To: licence@mara.gov.ie
Maritime Area Regulatory Authority, Menapia House, Drinagh, Wexford, Y35 RF29

Submission on MUL260006: digging and machinery on the shore at Cregg

Picture 9: view west from shore

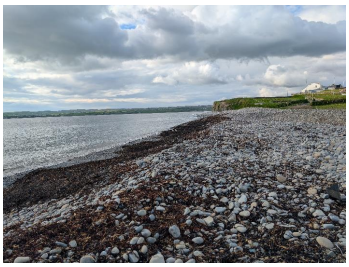
The inspection report for MAC260002 Area A records a site walkover from 17:59 to 18:50, with high water at 19:16 (4.4 m CD) and low water at 12:50 (0.8 m CD). The three photographs below are Pictures 9, 10 and 11 from that report, looking out from the shore. The sea reaches the foot of the cobble bank, and no lower shore is exposed.

The inspection took place in the last hour before high water. Much of the intertidal shore at Cregg, including the rock platform on which the reef grows, would have been under water at the time. The inspection could not have recorded the reef or the tree remains, and the public record contains no inspection of the Cregg foreshore by or for MARA at low tide.

Request: that MARA arrange an inspection of the Cregg foreshore at low tide, with reference to the reported reef, before the application is determined.
